**DOCUMENT 00 90 00
ADDENDUM**

ADDENDUM NO. [1] Date: October 24, 2018

**RE: PRENTICE SCHOOL DISTRICT
 ADDITION AND REMODELING BID PKG 3
 1025 TOWN ST
 PRENTICE, WI 54556
 HSR PROJECT NO. 18022**

A112R

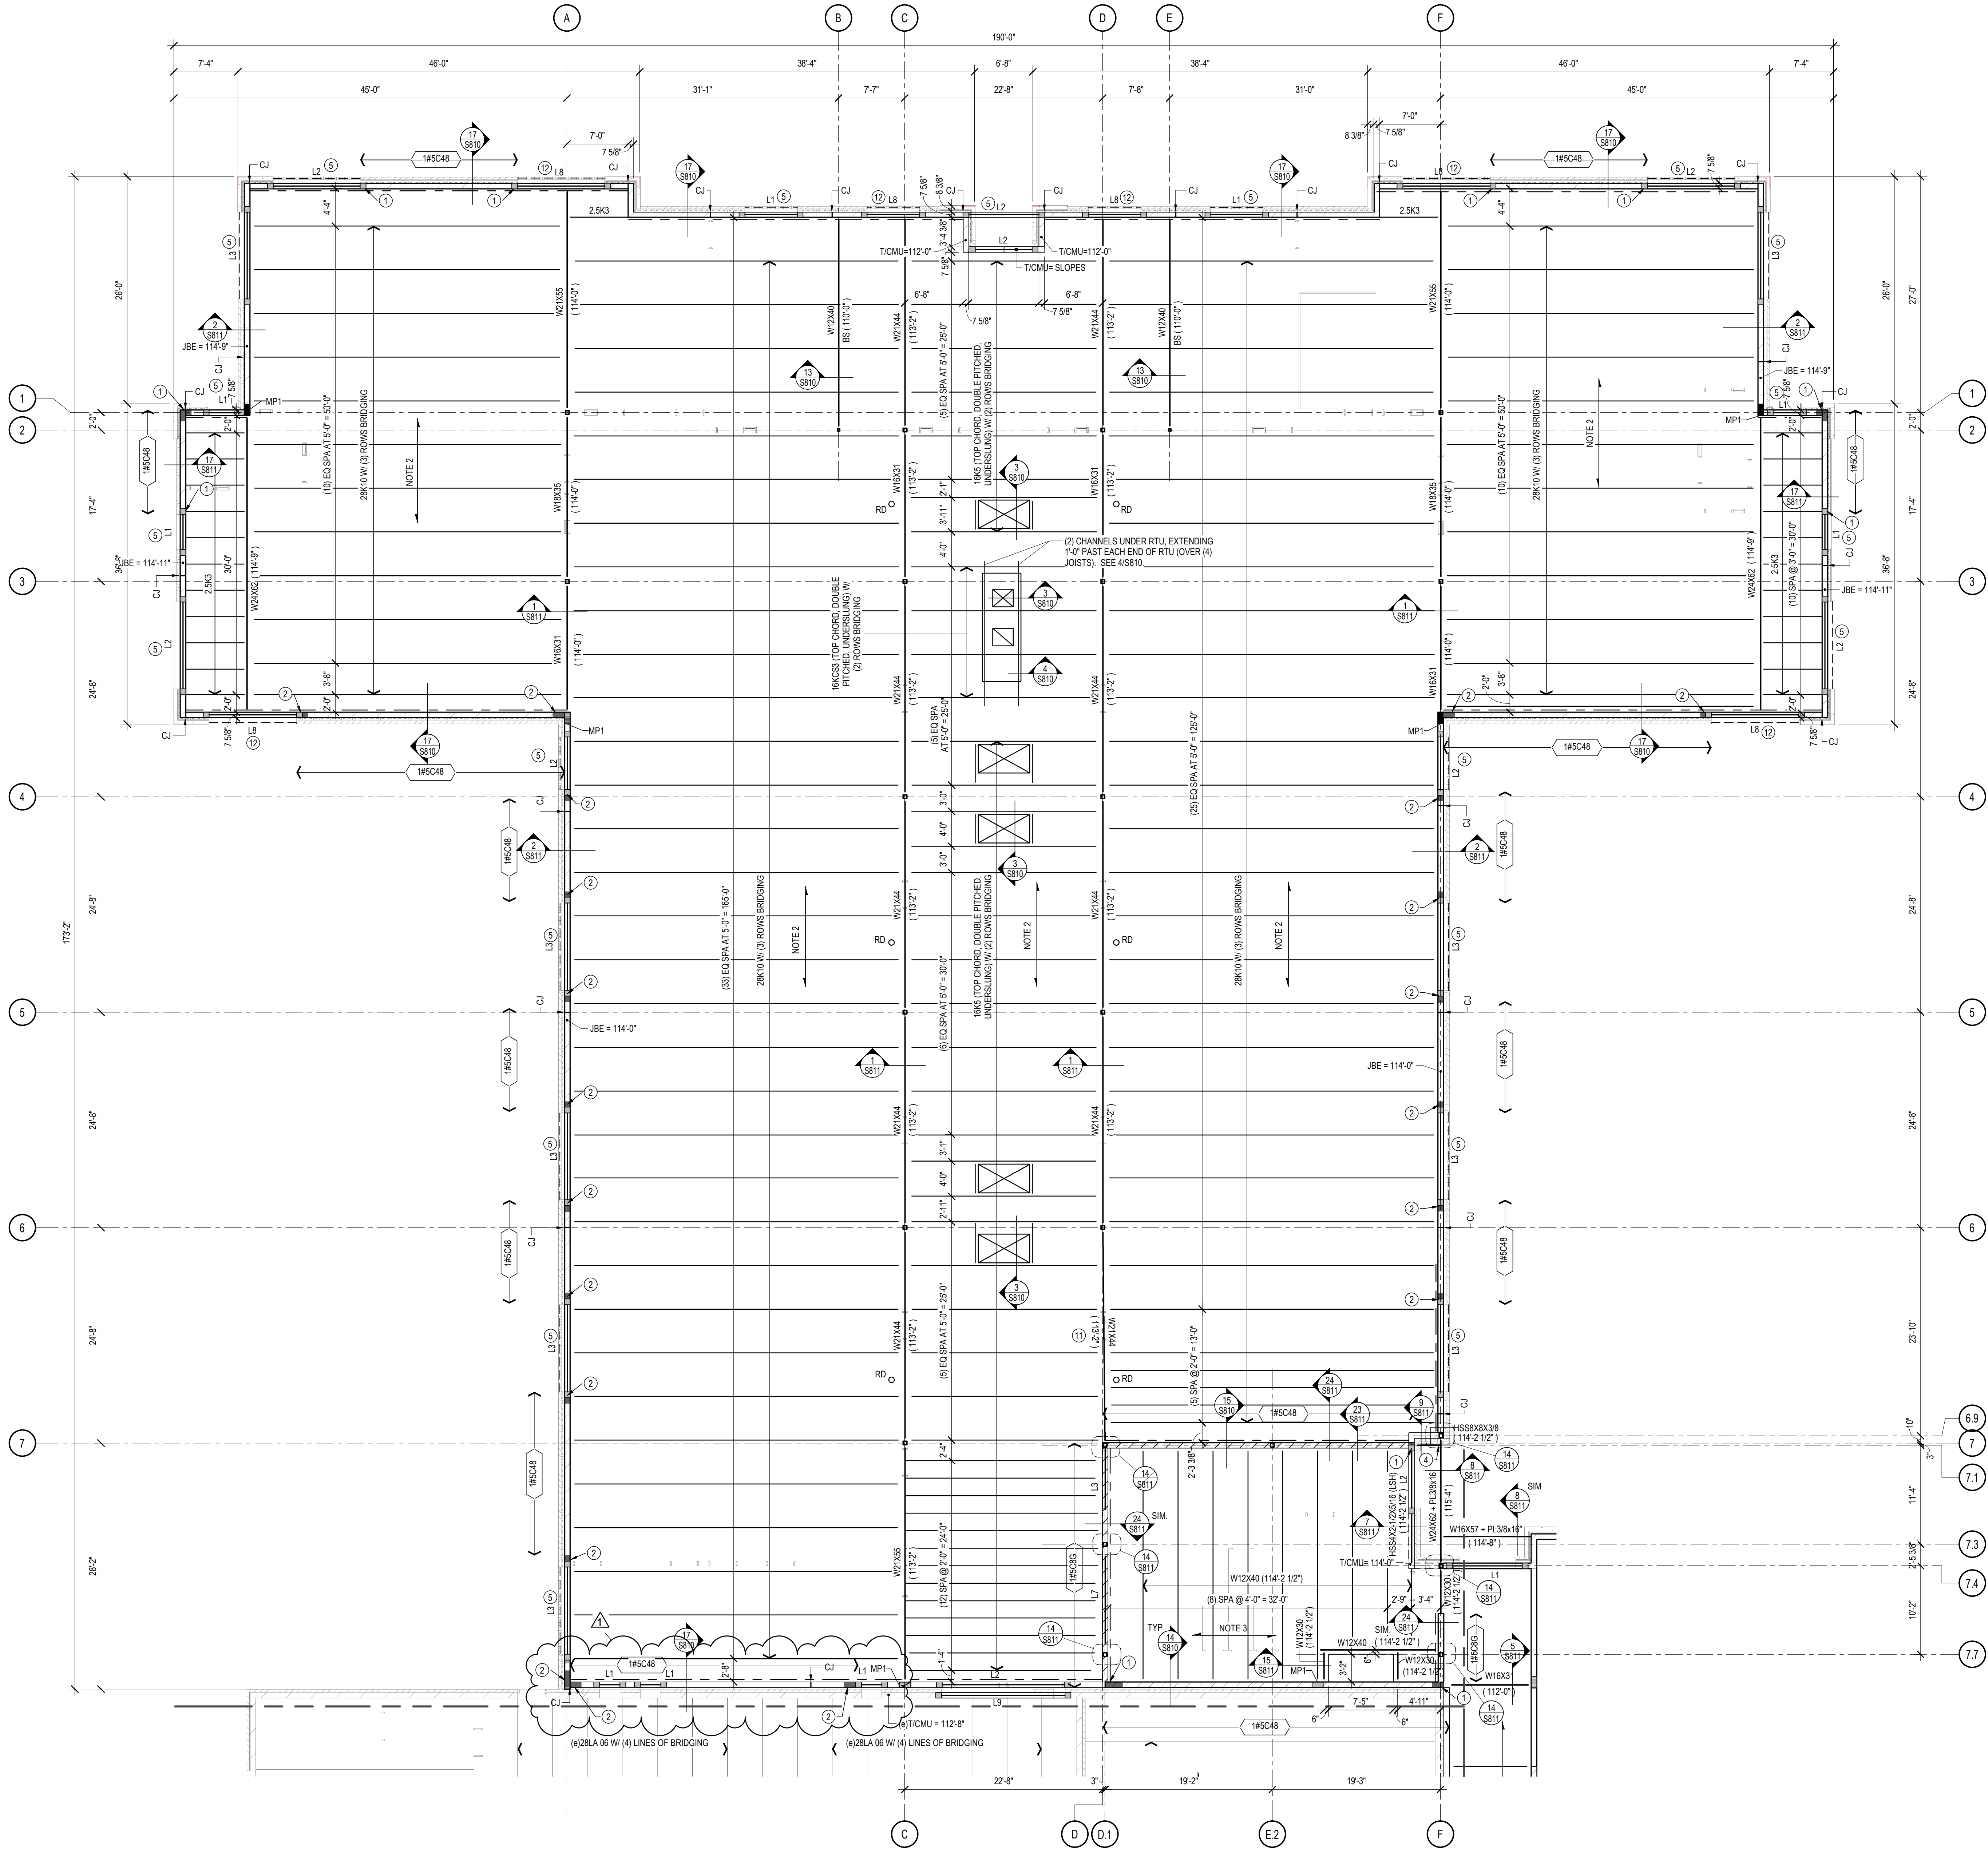
1. Sheet A112R FLOOR PLAN UNIT B 30 x 42 attached hereto
 - a. Revisions clouded on Drawing. Changes to masonry openings in existing and new wall.
2. Sheet S200R ROOF & PENTHOUSE FLOOR FRAMING-UNIT C 30 x 42 attached hereto
 - a. Revisions clouded on Drawing
